FACPAC Contract Change Order

Tier 1 Project: New Jefferson Elementary School

CHANGE ORDER NUMBER: 21-3
INITIATION DATE: 7/24/2020

Project:	Jefferson Elementary School 800 S Alves St. Henderson KY 42420	ASI No.:	005
		Date:	July 6, 2020
Owner:	Henderson County School 1805 2nd St. Henderson KY 42420	Project Number:	1807-244
		Contract for:	Civil
To:	John Hagan Codell Codell Construction 4475 Rockwell Road Winchester KY 40392		
RE:	Storm Conflict with 12" Water Main

Attachments: Revised C4.3, C4.4

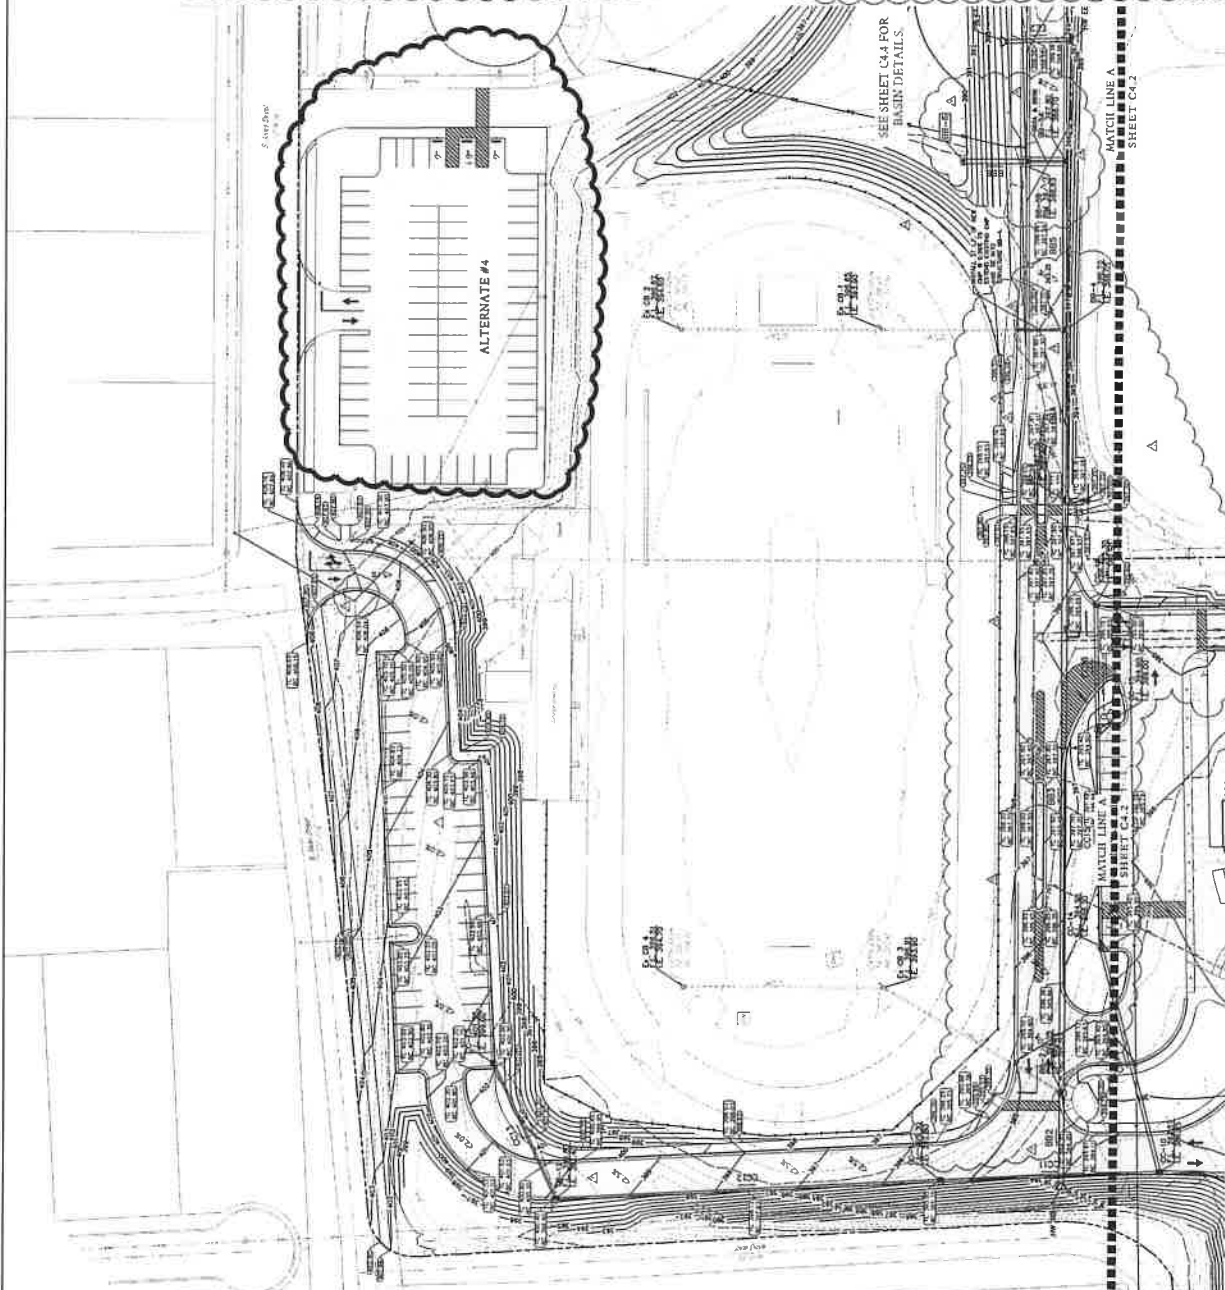
Please find the attached ASI 004 plans which changes pipe B5 from a single 36" diameter pipe to dual 24" pipes, changes storm structure BB-5 (48" diameter structure) to BB-5A (4'x6' structure), and adds structure BB-5B (4'x6' structure).

Drainage Plan
Area 1-10
Scale: 1" = 30'
Graphic Scale
1" = 30'

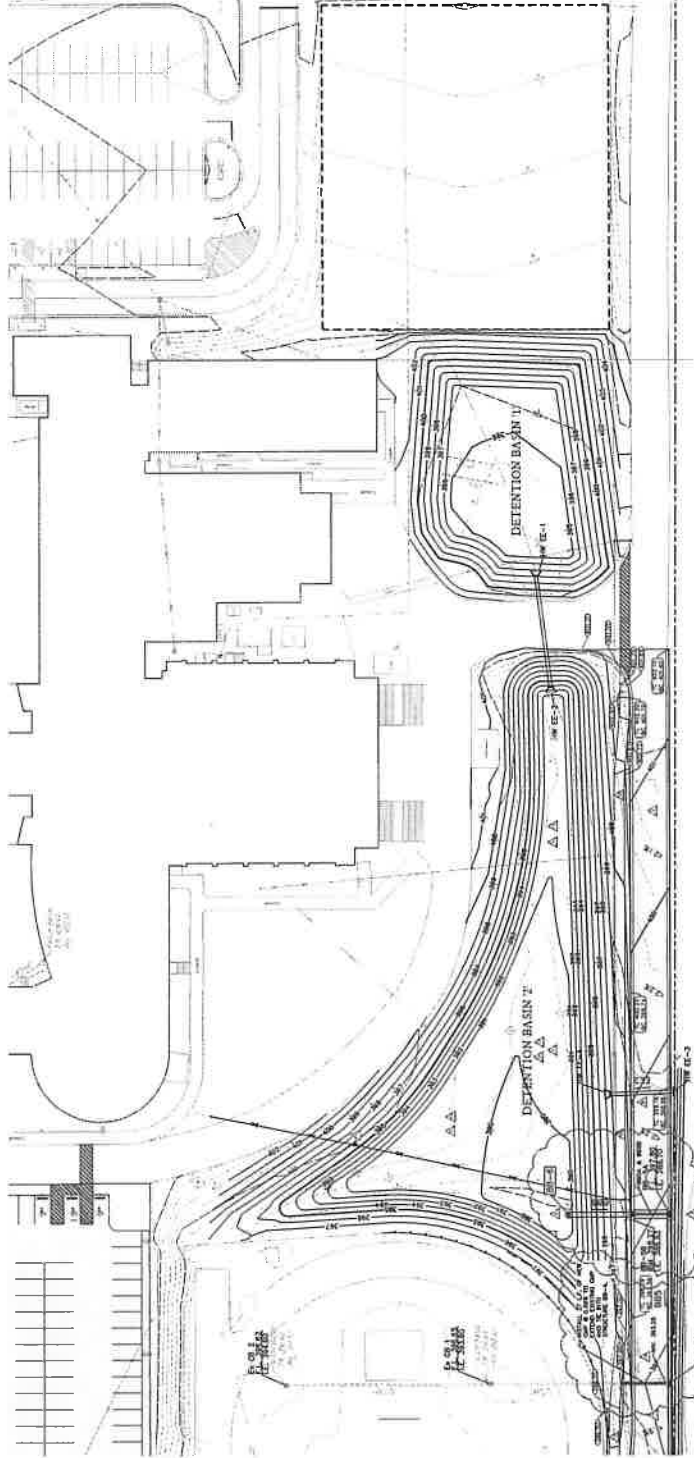
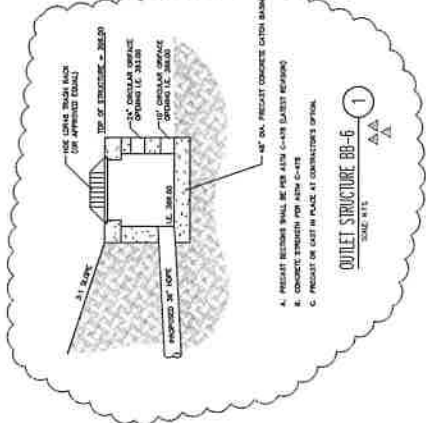
8. REFINED CONTOURS FOR DETENTION BASIN #2.
 9. REVISED OUTLET STRUCTURE BB-6 DETAIL.
- ARCHITECT'S SUPPLEMENTAL INFORMATION (6/9/2020)
10. REFINED SIDEWALK ALIGNMENT ALONG DETENTION BASIN 2 TO AVOID INTERFERENCE WITH POWER POLES AND UTILITIES.

11. REVISED BASIN 2 TO ACCOMMODATE REVISED SIDEWALK.
 12. REVISED OUTLET #1 STRUCTURE BB-6 DETAIL TO REFLECT MODIFIED BASIN 2 CALCULATIONS.
- ARCHITECT'S SUPPLEMENTAL INFORMATION (7/8/2020)

13. ADDED STORM STRUCTURE BB-5B, REVISED STORM STRUCTURE BB-5 TO 4x6 DOUBLE CURB INLET B-5A, REVISED STORM PIPE B5 TO TWIN 24" PIPES BB5A & BB5B.
 14. REVISED STORM PIPE EX1 TO BE EXTENDED INTO STRUCTURE BB-4.
